CITY OF ALBUQUERQUE

Re: Maher Warehouse, 4120 Culter Ave. NE, Grading and Drainage Plan
Engineer's Stamp dated 05-16-08 (H-17/D086A)

Re: Maher Warehouse, 4120 Culter Ave. NE, Grading and Drainage Plan
Engineer's Stamp dated 04-16-08 (H-17/D086A)

Based upon the information provided in your submittal received 10-30-15, the above referenced plan cannot be approved for Building Permit until the following comments are addressed:

James B. Clark
6 AUG 2015

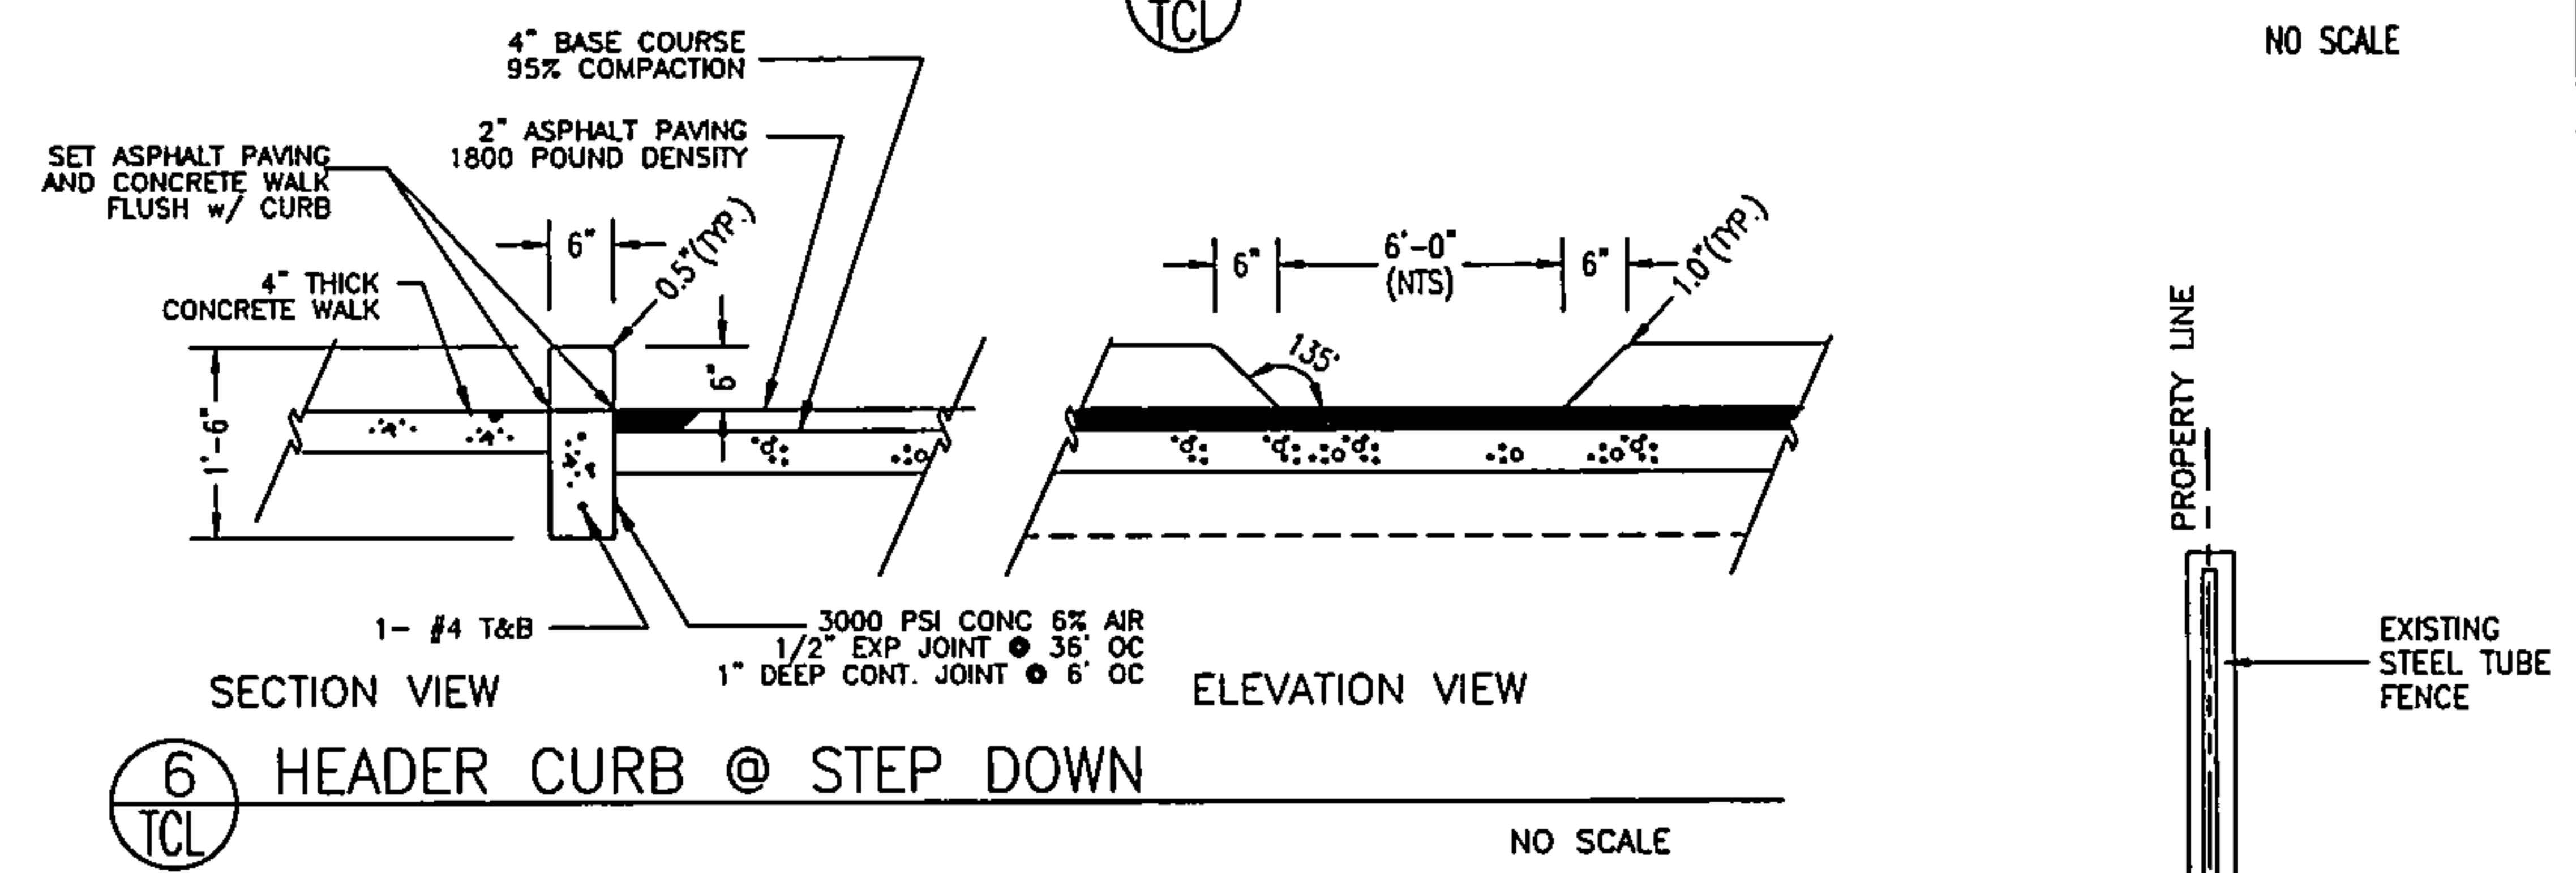
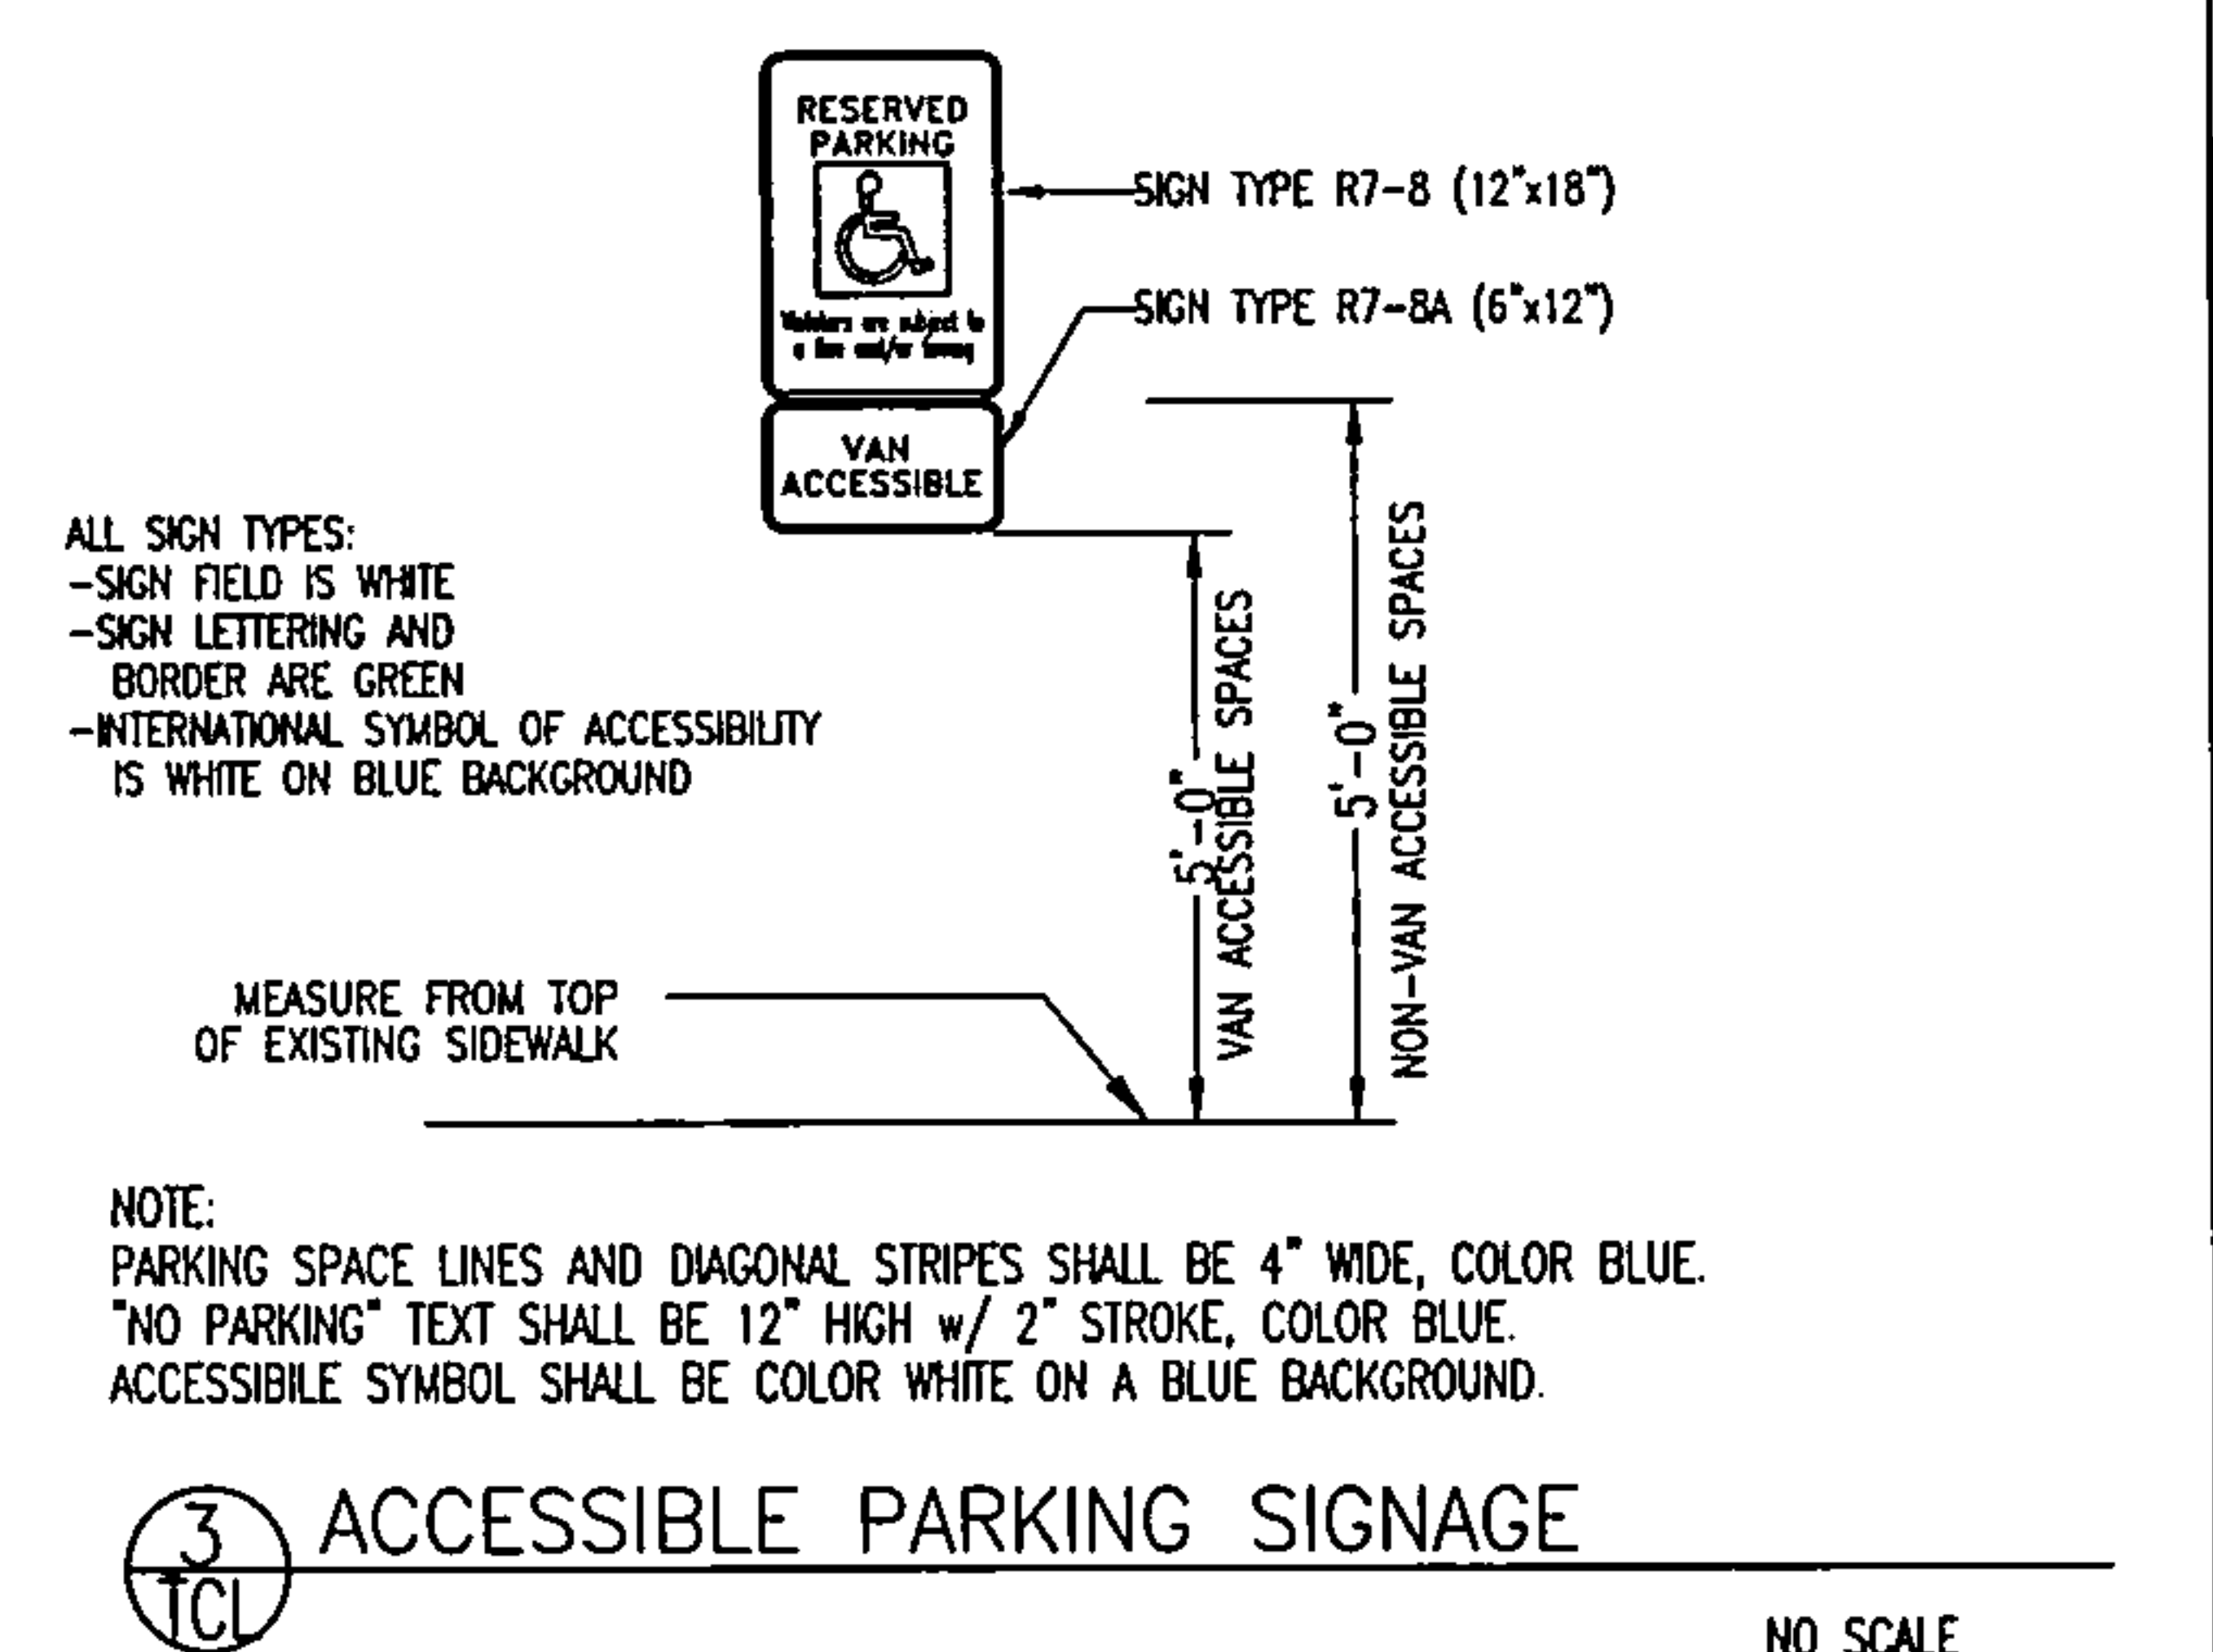
Mr. Clark, I noticed that you are putting Revision dates on the drawing dated 8-6-15. We need your final TCL Submittal Drawing with an updated Engr. Stamp date. Please resend the TCL BP Submittal drawing, along with the detail drawings with an updated Stamp date so that I may complete the TCL BP approval for your project.

Can you send me a detail of this to add to the drawing and please state the slope. Formalize the detail drawing, referencing the detail to the original drawing.

Gary:
Attached are two files:
1524D-Detail 6-TCL 8 1/2x11 format of the Step Down Curb Detail to add to the drawing;
and
1524D-TCL-12Nov15 24x36 format TCL Plan Sheet showing the Detail 6 and a callout note on the step down curb on the north edge of the parking area to supplant the 10 Nov 15 PDF file previously submitted.
Thank you,
Jim
